# Access Compliance Report

## Public Rights-of-Way

Intersection ID: 10026093	Main Street: ENGLAND_ST	Cross Street: N/A	Location: SE
ADA ID: 9DA755A9E1A8	Ramp Type: PerpDiag	Initial Pass/Fail: Fail	Overall Compliance: No
		Severity Score: 12.5

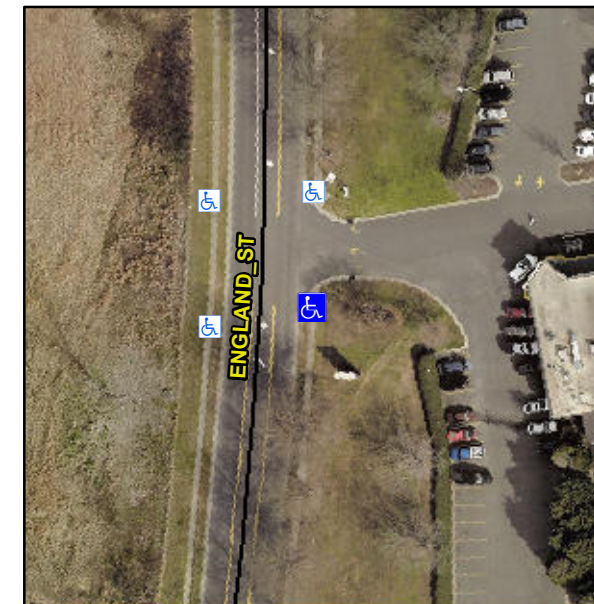
**Not Found, R304.2.2**

Compliance	Description	Data	Compliance	Description	Data
N/A	Ramp Length (in)	96.0	No	Ramp Slope (%)	9.0
Yes	Ramp Width (in)	48.0	Yes	Ramp XSlope (%)	1.1
N/A	Flare Type LT	N/A	N/A	Flare Type RT	N/A
N/A	Flare Slope LT (%)	N/A	N/A	Flare Slope RT (%)	N/A
N/A	Flare Traversable LT?	N/A	N/A	Flare Traversable RT?	N/A
N/A	Landing Length (in)	N/A	N/A	DWS Provided?	N/A
N/A	Landing Width (in)	N/A	N/A	DWS Contrast?	N/A
N/A	Landing Slope (%)	N/A	N/A	DWS Length (in)	N/A
N/A	Landing X Slope (%)	N/A	N/A	DWS Full Width?	N/A
N/A	Landing Curb? (Y/N)	N/A	N/A	DWS Offset (in)	N/A
N/A	Shared Landing?	N/A			
N/A	Gutter Ponding?	N/A	N/A	Gutter Slope (%)	N/A
N/A	Gutter Lip Ht (in)	N/A	N/A	Gutter X Slope (%)	N/A
N/A	Painted X Walk1?	No	N/A	Painted X Walk2?	No
	X Walk 1 Direction	To N		X Walk 2 Direction	To W
N/A	X Walk 1 Width (in)	N/A	N/A	X Walk 2 Width (in)	N/A
	X Walk 1 Slope (%)	1.4		X Walk 2 Slope (%)	5.1
	X Walk 1 X Slope (%)	6.1		X Walk 2 X Slope (%)	0.7

**Remove & Replace Curb Ramp With Two New Directional Ramps or Equivalent.**
